23 November 2020

Broome North Water Management Strategies and Plans Broome North District Water Management Strategy - Review of DSP Amendment 2

This letter has been prepared to support the submission of the Broome North District Structure Plan (DSP) Amendment 2. This letter reviews the key changes to the DSP and outlines the relevant matters relating to the approved DWMS.

Attachment 1 – Broome North District Structure Plan (DSP) Amendment 2

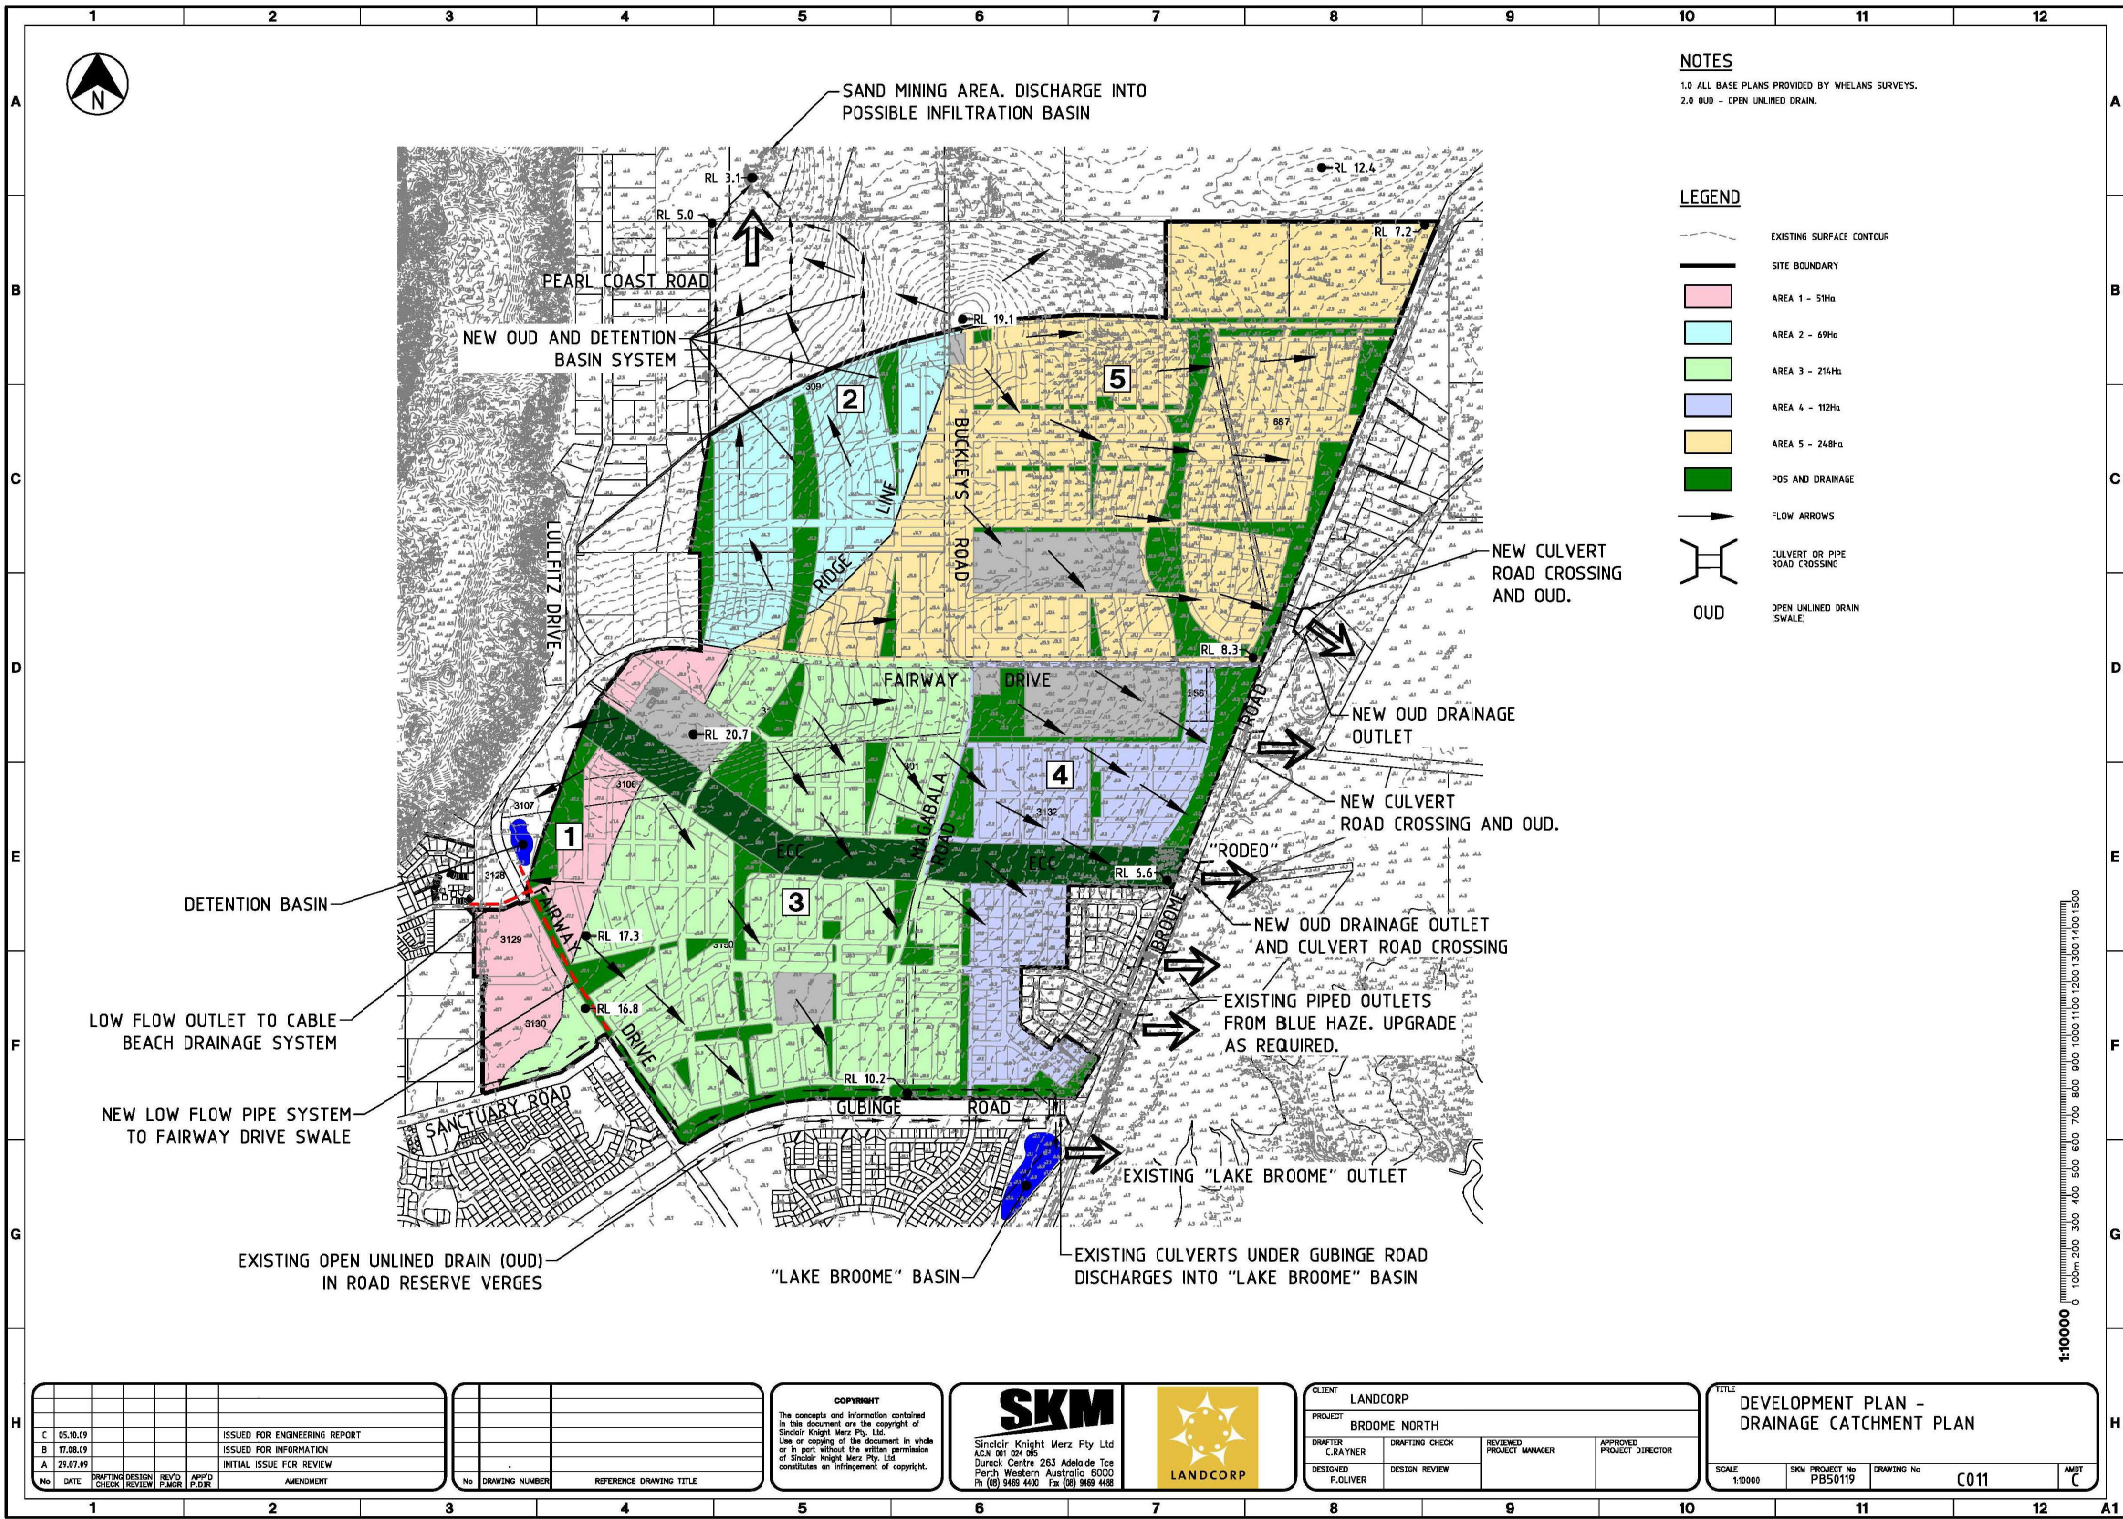
This DSP Amendment 2 area covers the area as shown in Attachment 1. The area is bounded by Broome Road to the east and Gubinge Road to the south.

- Relocation of the local centre from the Stage 1 Local Development Plan (LDP) area to the Stage 3 LDP area in alignment with the Shire of Broome Local Commercial Strategy (Geografia and SITE Planning and Design 2017).
- Relocation of the District Open Space (DOS) from LDP2 to future LDP area to the north of Fairway Drive as per previous agreement as part of the Stage 2 LDP process.
- Inclusion of Bush Living area within north-eastern extent of DSP area.

Relocation of the local centre from Stage 1 LDP area to Stage 3 LDP area

Relocation of the District Open Space from LDP2

Inclusion of Bush Living area

The Bush Living area depicted within the Broome North DSP Amendment 2 was included within catchment 'Area 5' of the Broome North DWMS stormwater management plan (Attachment 2). This area has retained its proposed use and is accounted for within district scale stormwater management, including preliminary sizing of drainage corridors and outlets.
